**SUBJECT: THE DALLES LOCK AND DAM  
CONTRACT NO. W9127N-06-D-0009, TASK ORDER NO.0004  
NORTH AND EAST FISH LADDER RELIABILITY  
ASSESSMENT REPORT, 100% SUBMITTAL**

## NORTH AND EAST FISH LADDER RELIABILITY ASSESSMENT REPORT

100% SUBMITTAL

**Comment Report: Comments By ITR**

FIGURE 1  
THE DALLES NORTH FISH LADDER

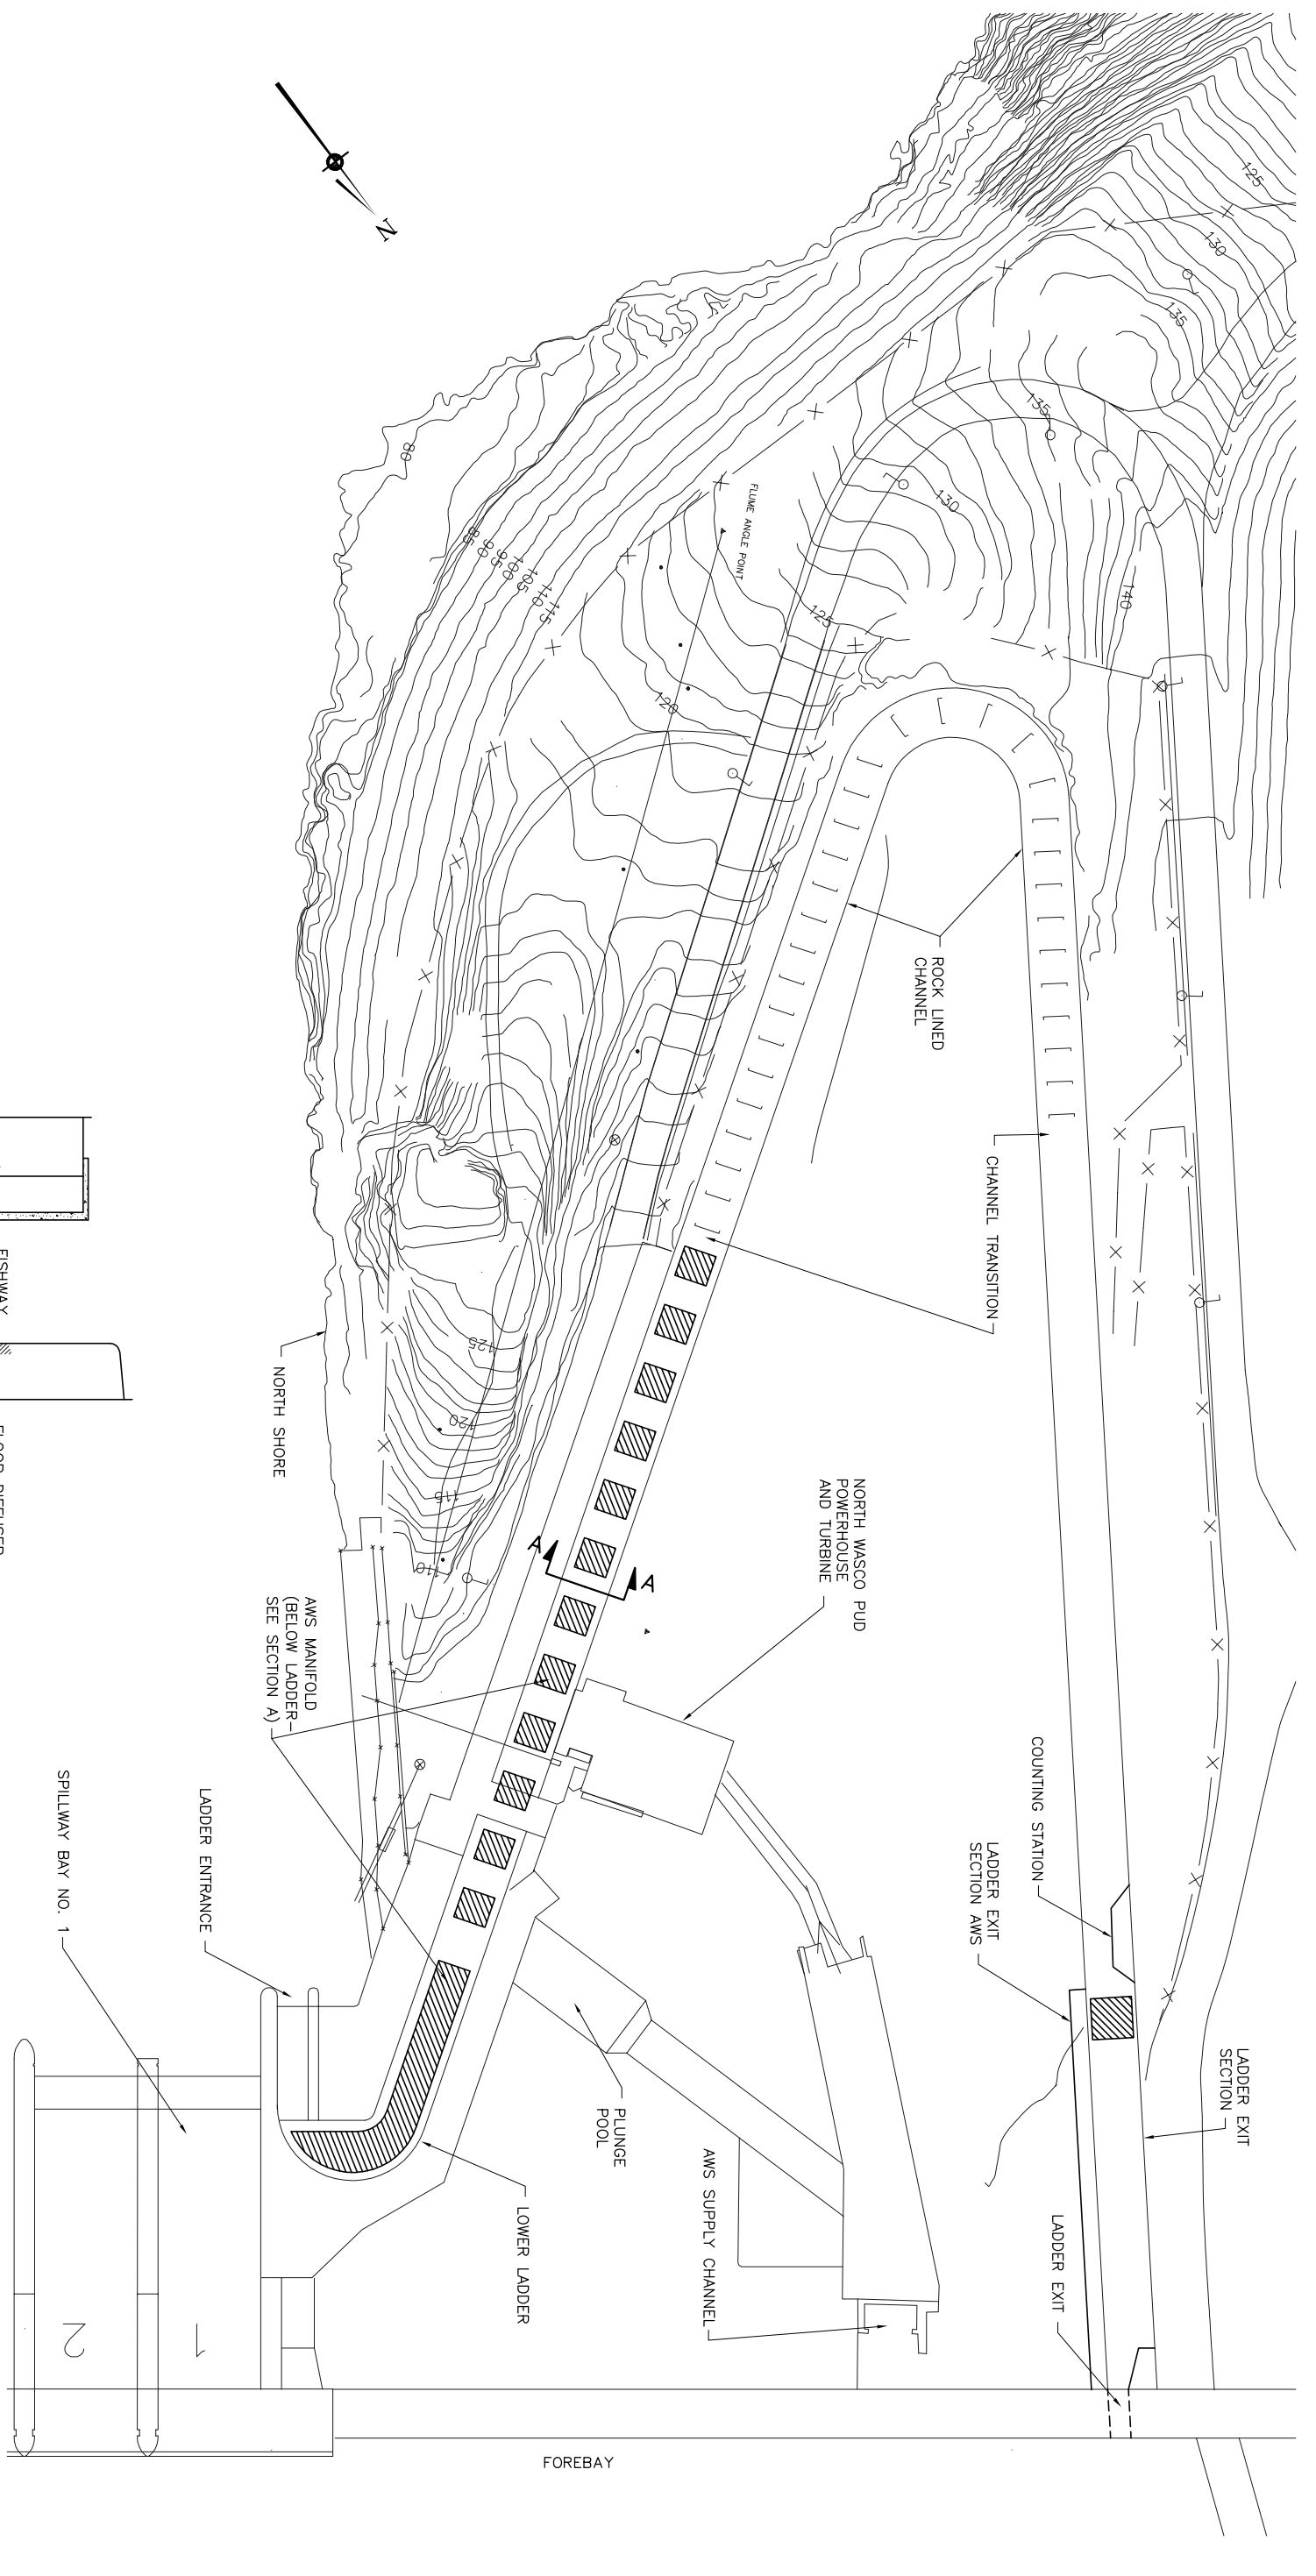
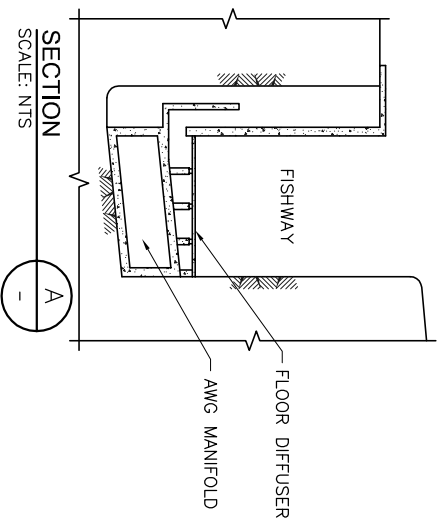
<a href="#">Id</a>	<a href="#">Discipline</a>	<a href="#">Section/Figure</a>	<a href="#">Page Number</a>	<a href="#">Line Number</a>
05	Civil	2.4.1H and Figure 1	8

The Exit Section AWS described here should be shown on Figure 1.

Appendix E, Figure 1 has been revised to show the Exit Section AWS.

FIGURE 2  
 THE DALLES EAST FISH LADDER  
 NFL/EFL RELIABILITY  
 ASSESSMENT

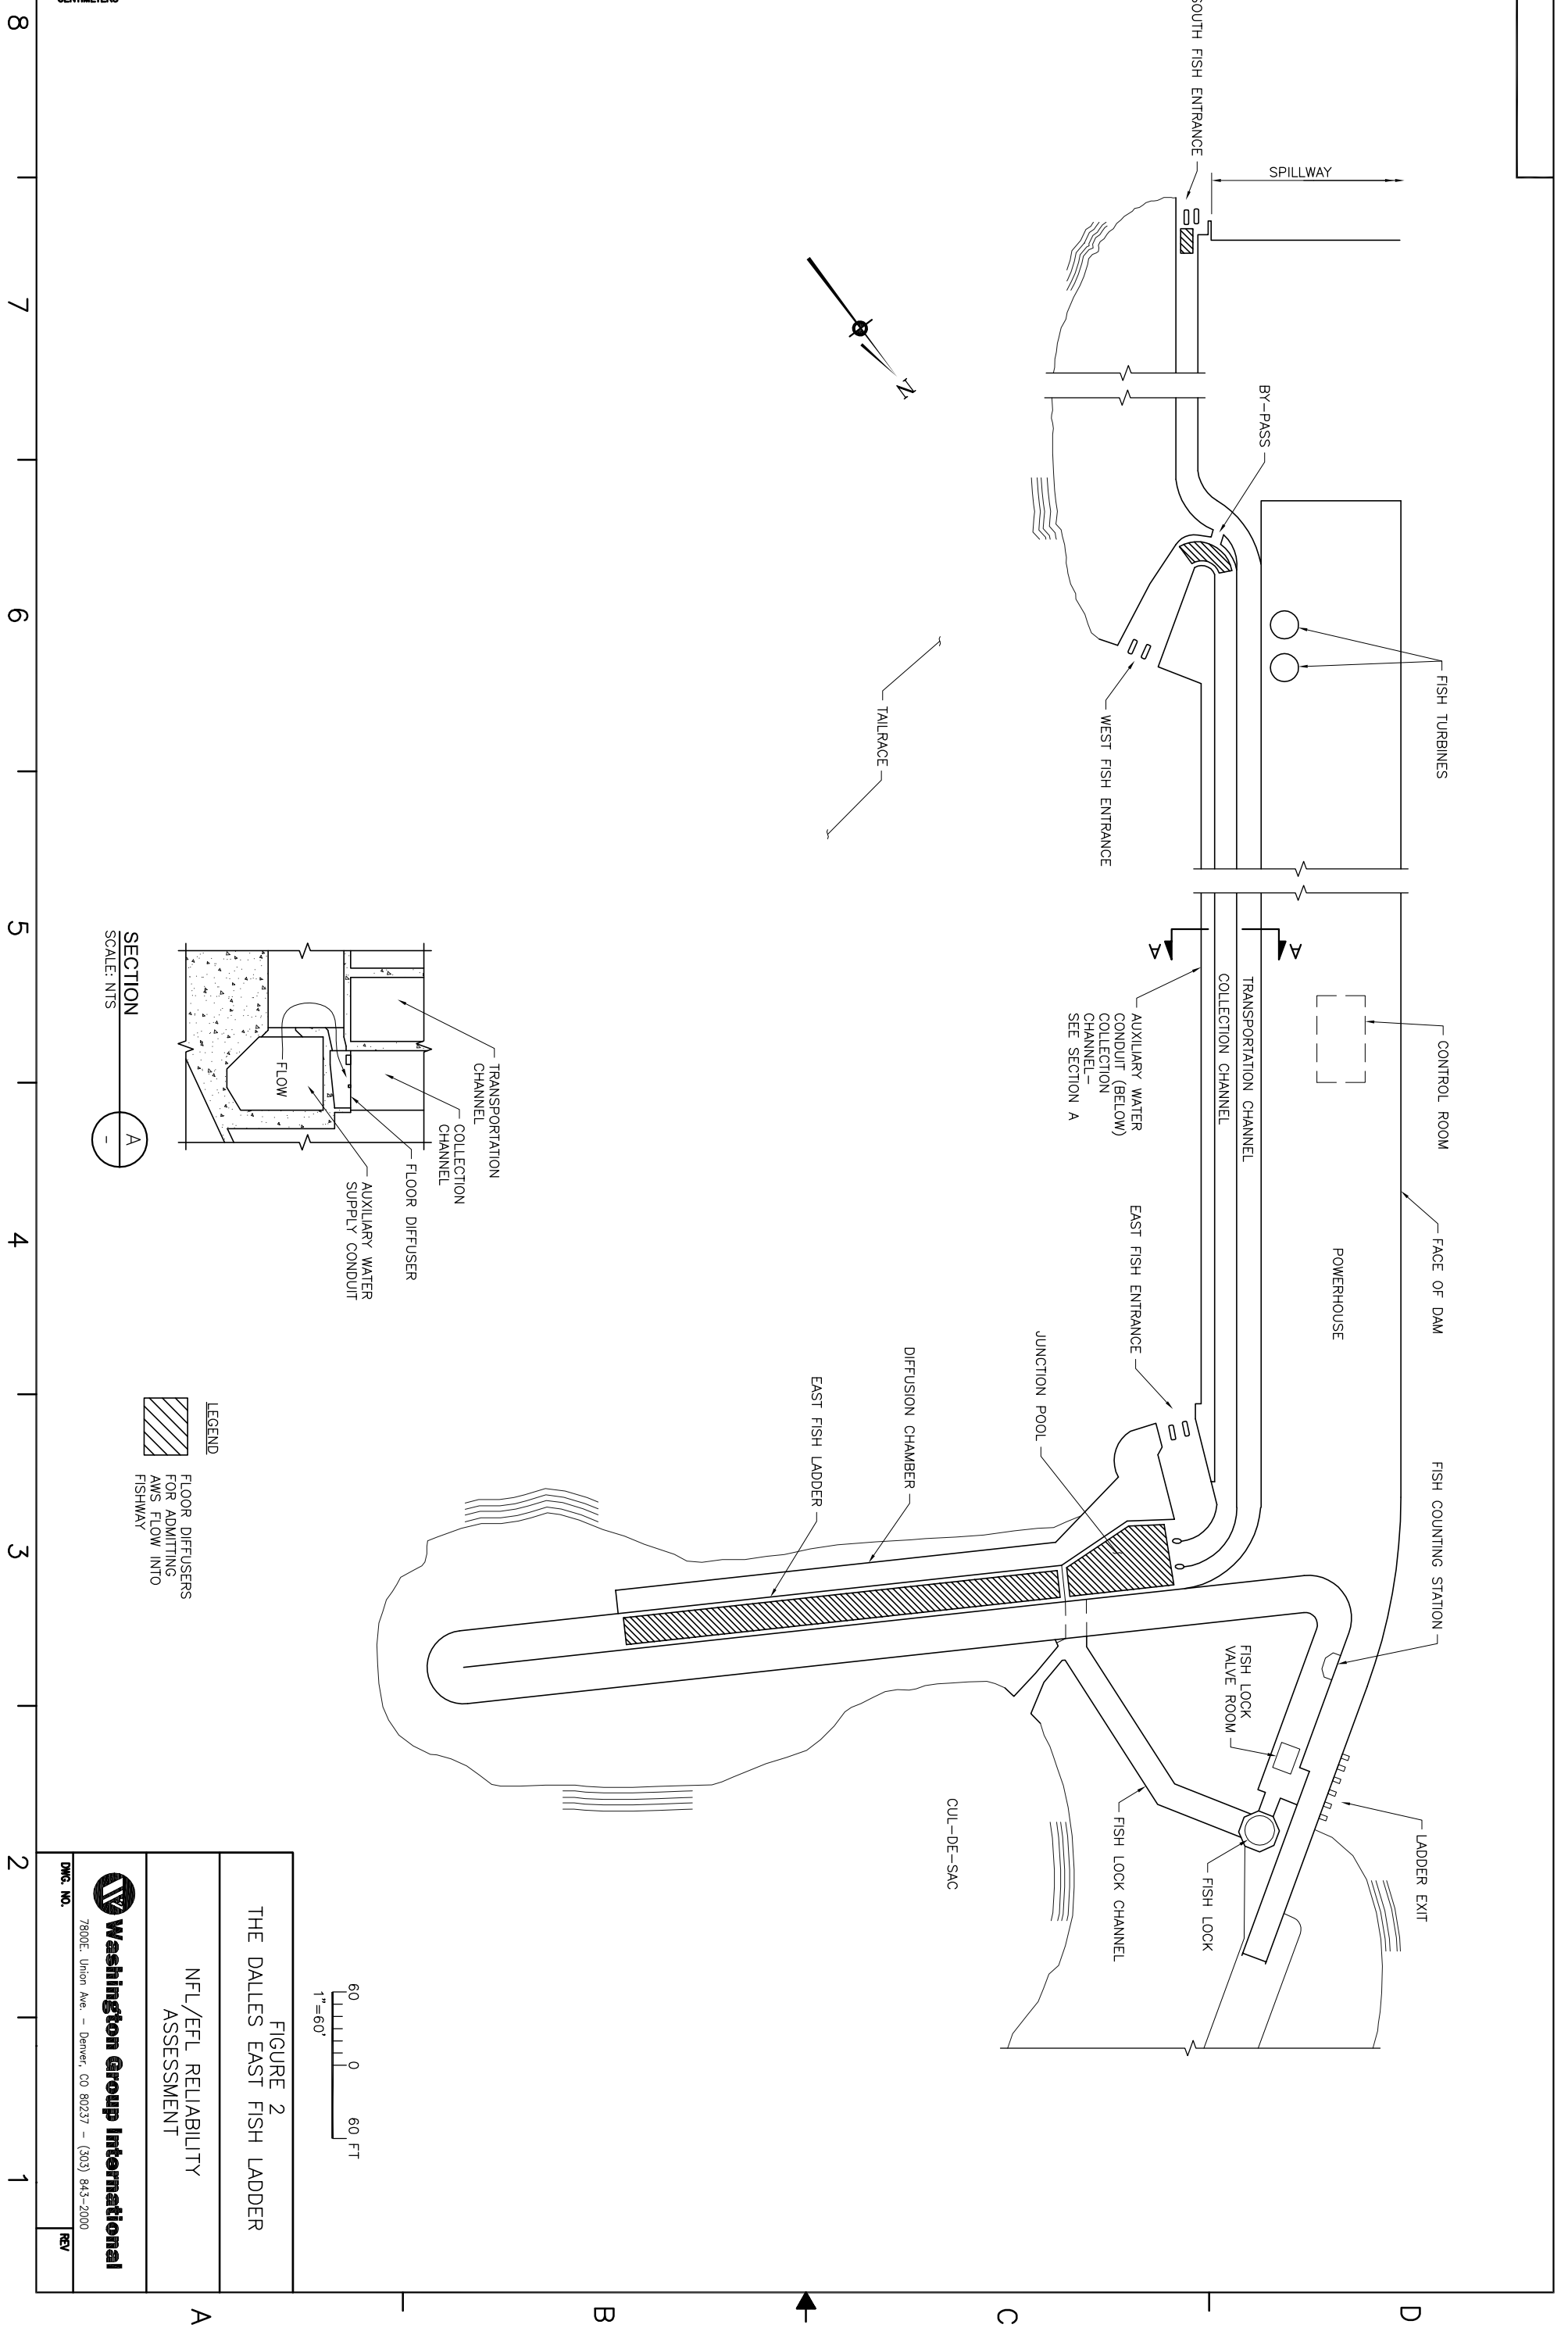
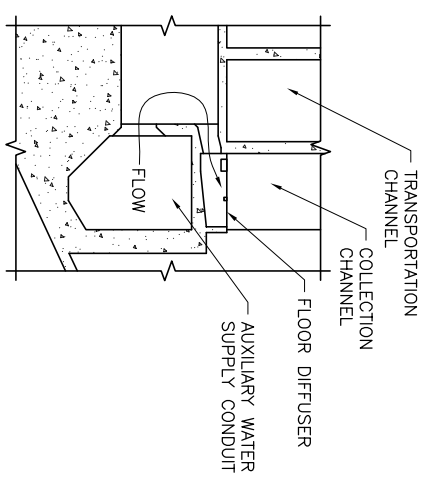
<a href="#">Id</a>	<a href="#">Discipline</a>	<a href="#">Section/Figure</a>	<a href="#">Page Number</a>	<a href="#">Line Number</a>
01	Civil	1.0 East Fish Ladder/Figure 2	2	3
<b>Comment:</b> The AWS could be better defined as it is first introduced into the report in text form and on a figure.  Submitted By: M Pavone Submitted On: 9/14				
<b>Response:</b> The text has been changed at first mention of AWS, which is for north ladder. Appendix E figures have been revised to show AWS in Section A.				
<hr/>				
<a href="#">Id</a>	<a href="#">Discipline</a>	<a href="#">Section/Figure</a>	<a href="#">Page Number</a>	<a href="#">Line Number</a>
02	Civil	2.4.1 A - I	5 - 8	
<b>Comment:</b> Next to each system heading it would be helpful to put in parenthetically the System Number (e.g. Ladder Entrance (System 1) and so on. This will provide better linkage to the analysis and evaluation part of the report.  Submitted By: M Pavone Submitted On: 9/14

<u>Id</u>	<u>Discipline</u>	<u>Section/Figure</u>	<u>Page Number</u>	<u>Line Number</u>
08	Civil	Figure 2		
<p><b>Comment:</b>  The North arrow should be included.  The AWS should be more clearly depicted on the figure. At least as related to the discharge points near the entrances.</p> <p>Submitted By: MP . Submitted On: 9/14</p>				
<p><b>Response:</b>  Appendix E, Figure 2 has been revised to show a north arrow and the AWS.</p>

<b>Response:</b> System numbers have been added.				
<hr/>				
<a href="#">Id</a>	<a href="#">Discipline</a>	<a href="#">Section/Figure</a>	<a href="#">Page Number</a>	<a href="#">Line Number</a>
03	Civil	2.4.1 D	6	
<b>Comment:</b> Is the System the North Wasco Powerhouse as it is stated here, or is it the PUD Turbine as it is described in the analysis portion of the report? The analysis focuses on the turbine and therefore 2.4.1D should be so headed.  Submitted By: M Pavone Submitted On: 9/14				
<b>Response:</b> "Powerhouse" has been changed to "Turbine" in the text.				
<hr/>				
<a href="#">Id</a>	<a href="#">Discipline</a>	<a href="#">Section/Figure</a>	<a href="#">Page Number</a>	<a href="#">Line Number</a>
04	Civil	2.4.1E	7	
<b>Comment:</b> Is the "system" the Secondary AWS System or is it the Plunge Pool as it has been defined in the evaluation portion of the report? The terminology should be consistent.
